DOCUMENT CHANGE REQUEST

DCR number 124	Changes required for: General	Originator: S Thacker
Date: 2004/06/08	Date sent: 2004/06/08	Organisation: ESA/ESTEC
Status: IMPLEMENTED

Title:	CMOS Quad 3-State NOR R/S Latches, based on type 4043B		
Number:	9202/042	Issue:	1

FIGURE 3(c) - CIRCUIT SCHEMATIC (EACH LATCH)

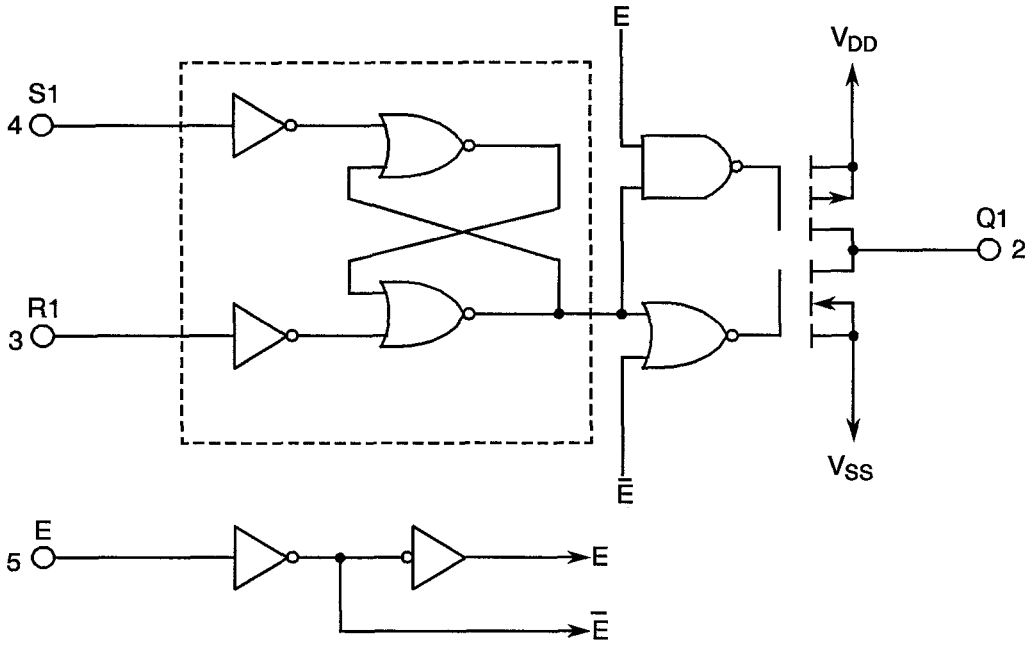
Page 14 Figure 3(c) Circuit Schematic

Figure is amended to reflect an equivalent NOR Latch (as para 1.8 Functional diagram in amended spec) - see original and amended version as attached.

Original figure was incorrect (it was an equivalent NAND Latch)
